Waste Permits Division Correspondence Cover Sheet

Re: Response to Technical Notice of Deficiency Letter
City of Meadow Landfill
Meadow, Terry County, Texas
Municipal Solid Waste Permit Number: 2293C
Tracking No. 30060987; RN101570976/CN606025534
Major Permit Amendment

NOD 1 TABLE

G:\0120\809\EXPANSION 2023\PART III\IIIM\SHEET IIIM-6-REMAINING CAPACITY.dwg, jwilson, 1:2

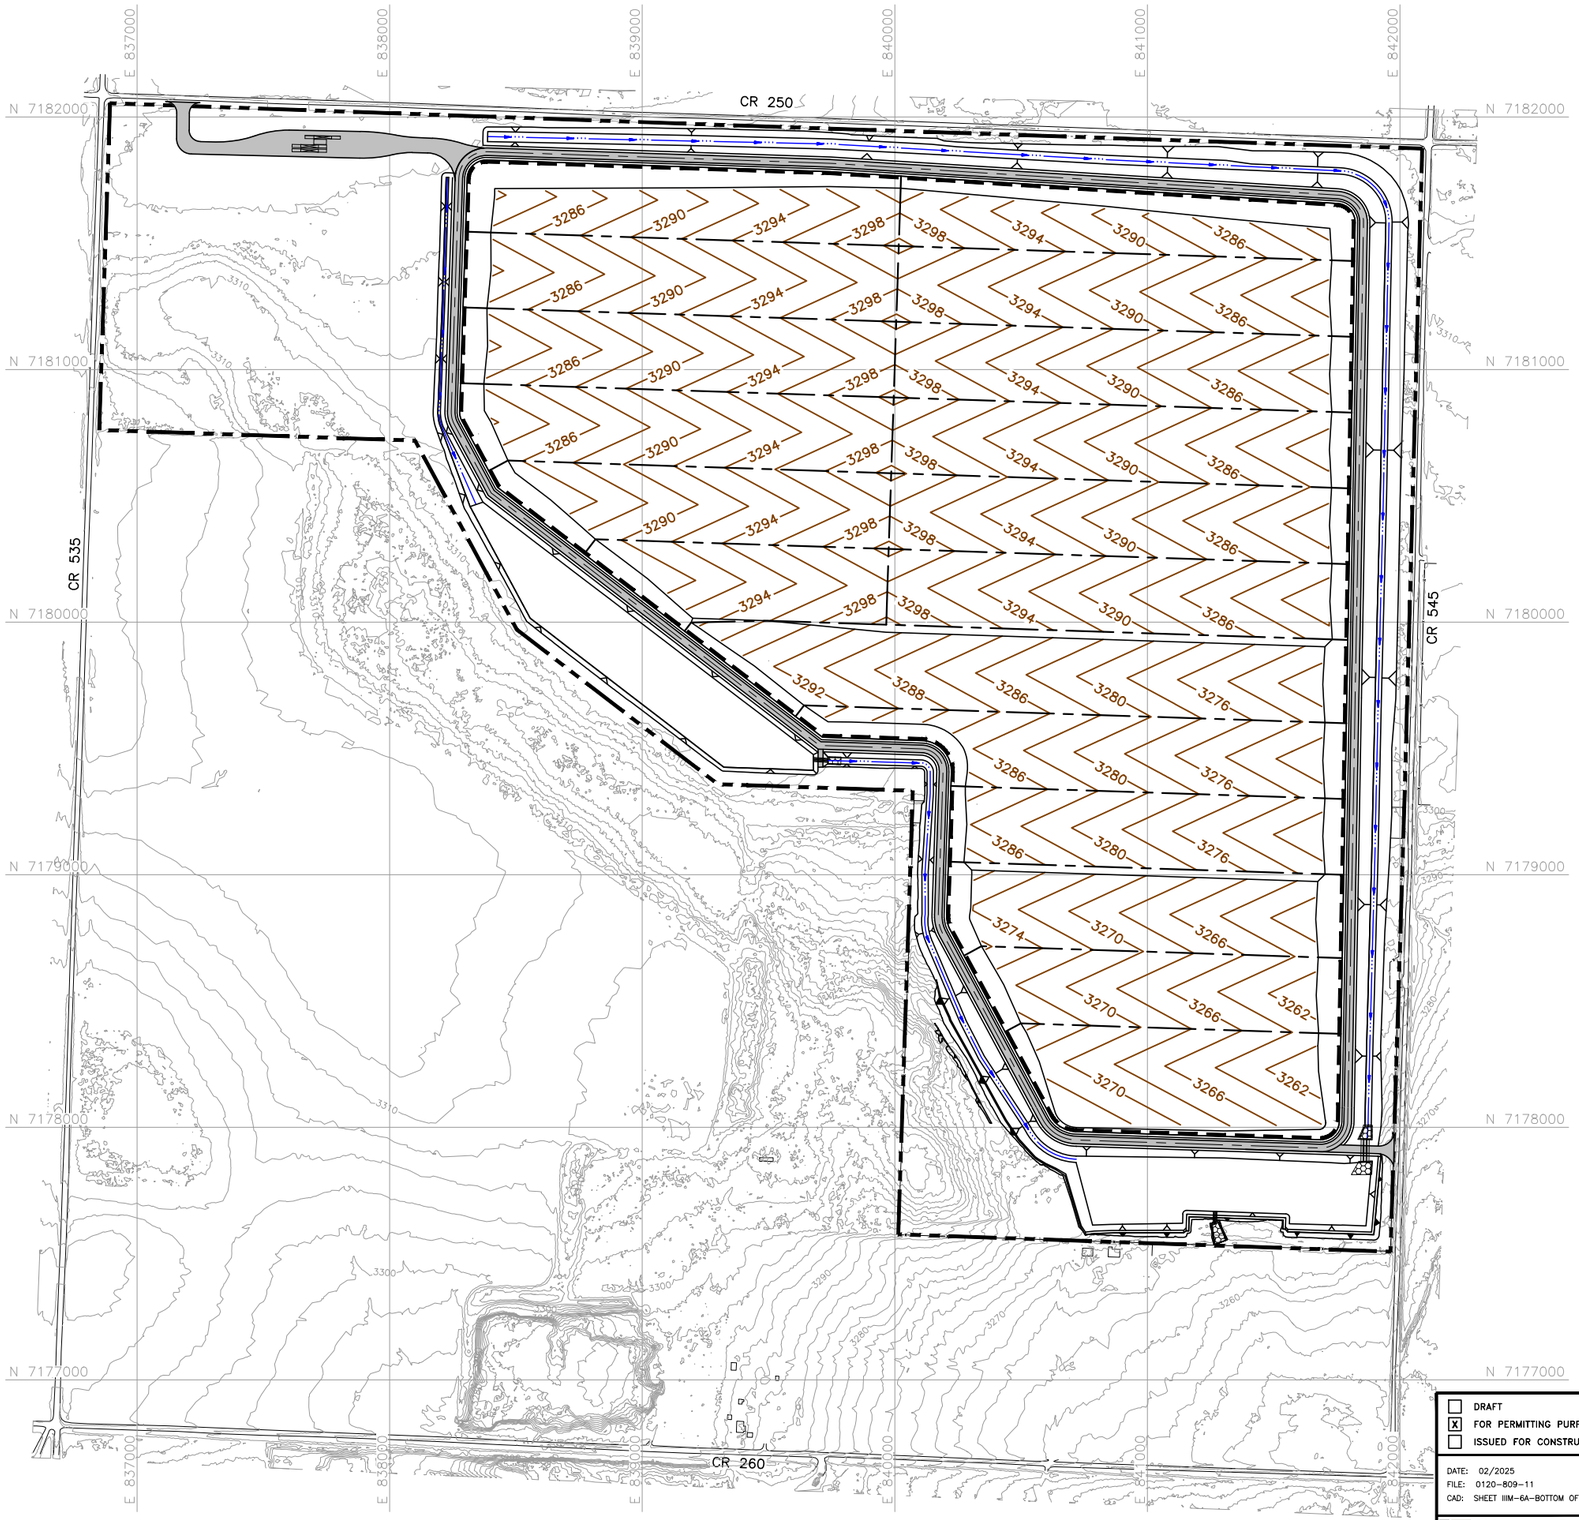
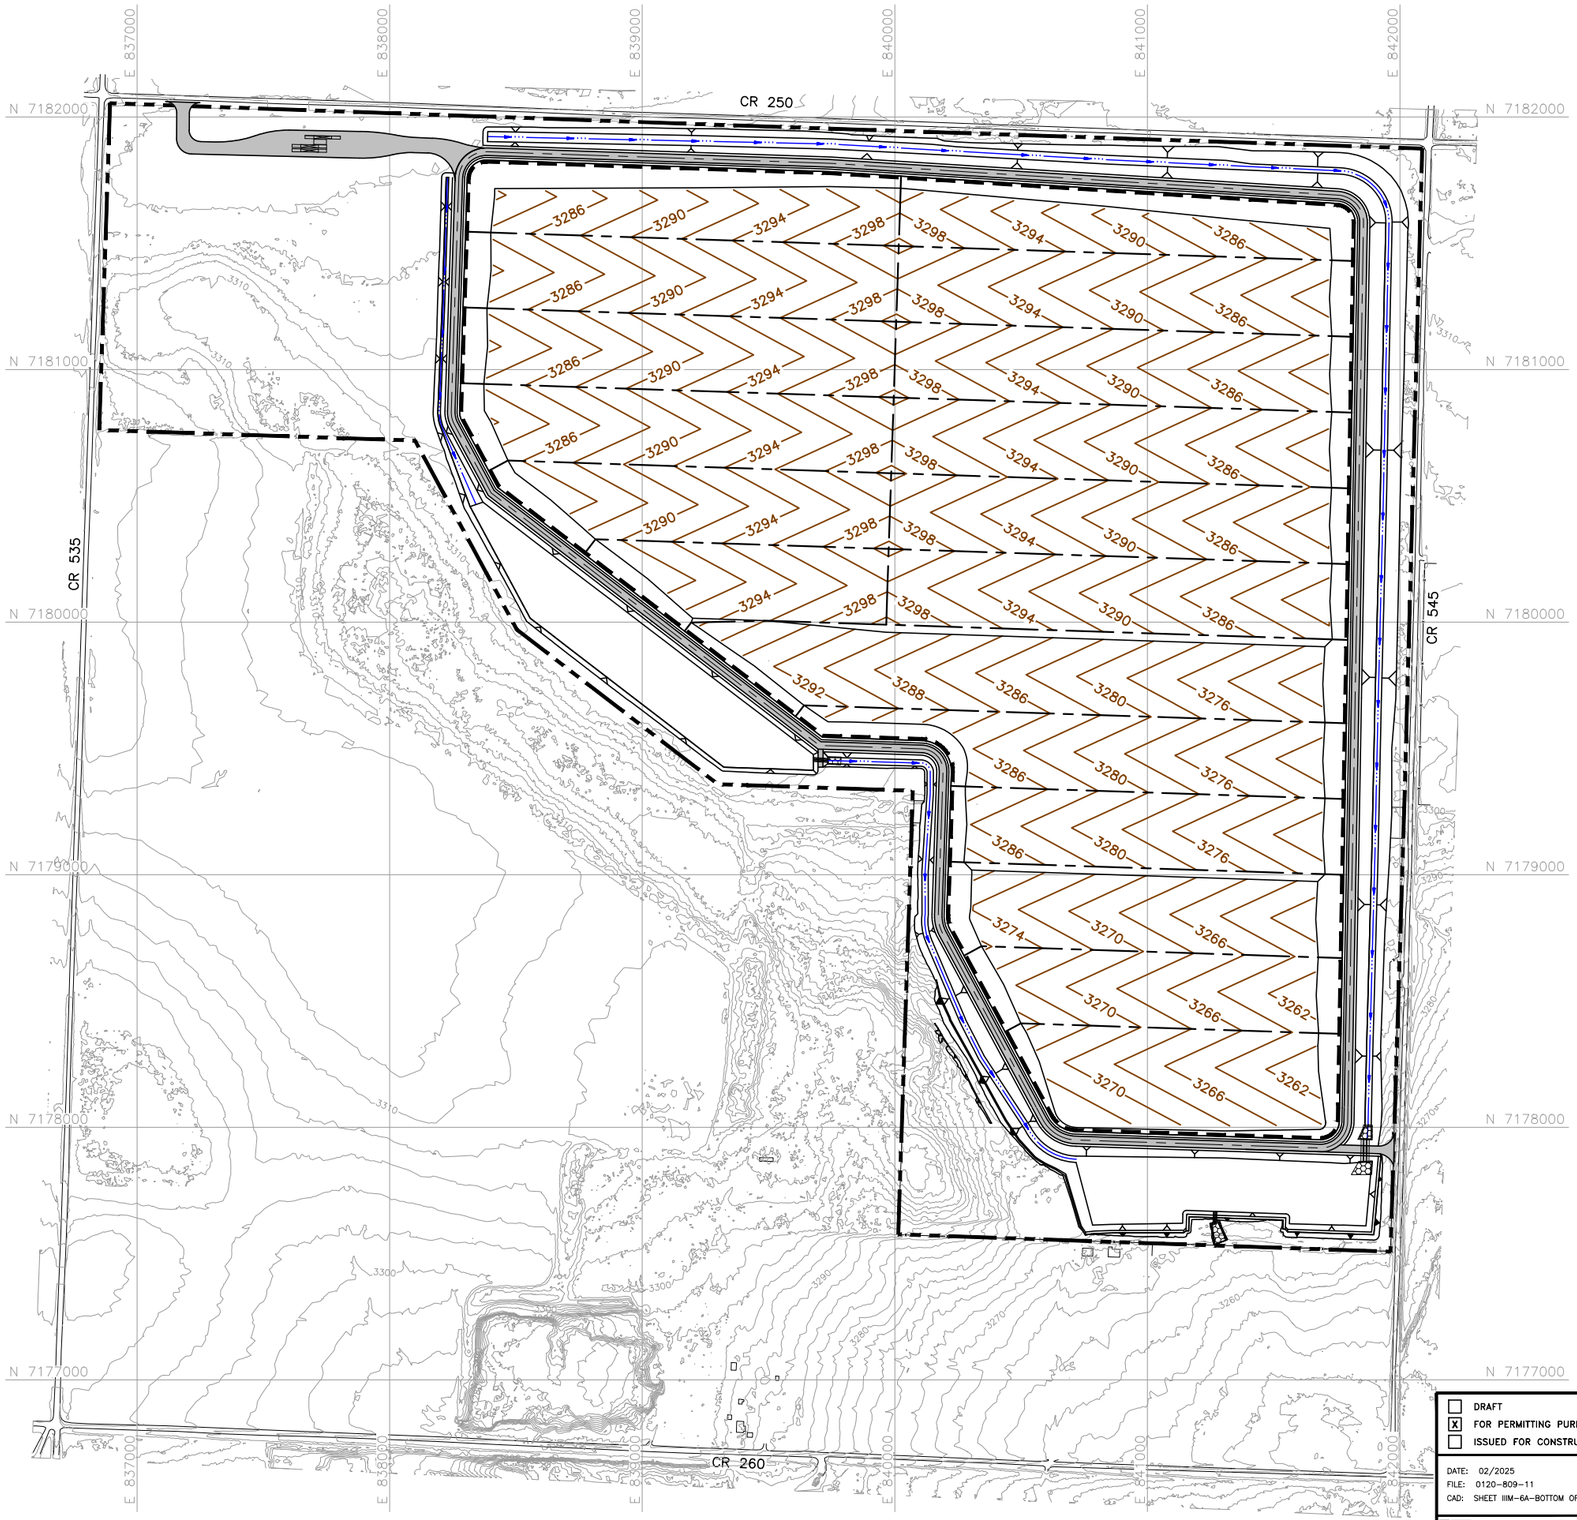
13	12	Part III, Appendix IIIM, Sheet IIIM-6	330.57(d)	Add Sheet IIIM-6 to the Appendix IIIM Table of Contents. **Response:** Sheet IIIM-6 has been added to the Appendix IIIM Table of Contents.
14	12	Part III, Appendix IIIM, Sheet IIIM-6	330.57(d)	Provide separate figures to show the projected depth of remaining fill, projected bottom of waste contours, and projected top of intermediate cover. Also specify if depth to remaining fill is in feet. **Response:** Additional figures (IIIM-6A and IIIM-6B have been added showing the bottom of waste contours and top of intermediate cover grades. Additionally, the legend has been revised to indicate that the depth to remaining fill is in feet.
